Tennessee Valley Authority, 1101 Market Street, LP 5A, Chattanooga, Tennessee 37402-2801

In the Matter of) Docket Numbers 52-014 and 52-015
Tennessee Valley Authority)

NUCLEAR REGULATORY COMMISSION (NRC) – BELLEFONTE NUCLEAR PLANT (BLN) – RESPONSE TO NRC INFORMATION NEEDS RELATED TO ACCIDENTS, HEALTH PHYSICS, LAND USE, AND METEOROLOGY

**RESPONSES TO NRC
INFORMATION NEEDS**

**Area of Nonattainment for PM-2.5
in Jackson County
(Identified by U.S. Census Bureau
Block Group 01-071-9503-1)**

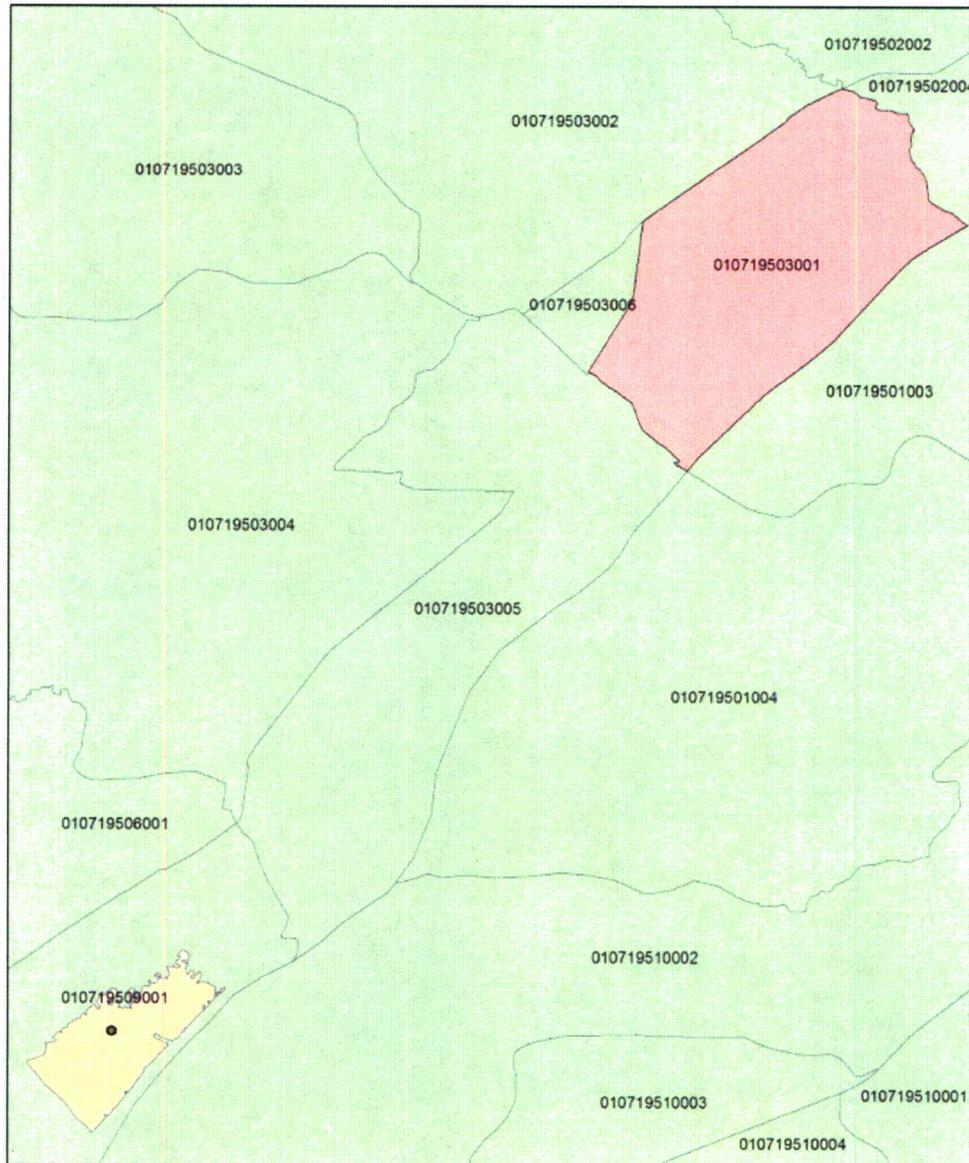
Need to meet with appropriate folks in the utility for ...2) addressing issues related to the site proximity to an air quality non-attainment area

During the week of March 31 through April 4, 2008, the NRC staff conducted an audit of the BLN site, including a review of the documentation supporting the BLN ER. The NRC meteorology reviewer requested additional information, including identification of the area in Jackson County that is in nonattainment. The Environmental Protection Agency identifies the nonattainment area in Jackson County as U.S. Census 2000 block group 01-071-9503-1 and stipulates that the area is in non-attainment for PM-2.5 (particulate matter with a diameter less than 2.5 micron). The non-attainment area is approximately 10 miles northeast of the BLN site boundary, as shown in the illustration provided as Attachment A to this enclosure.

The above classification of Jackson County as nonattainment for PM-2.5 is a result of being included in the AL-TN-GA area, which includes Chattanooga, Tennessee. The EPA identifies the PM-2.5 nonattainment area in Jackson County as U.S. Census 2000 block group 01-071-9503-1. Jackson County is part of the Tennessee River Valley (Alabama) – Cumberland Mountains (Tennessee) Interstate Air Quality Control Region. For Jackson County itself, the levels of all criteria pollutants are well within the EPA air quality standards for 2003 through 2005.
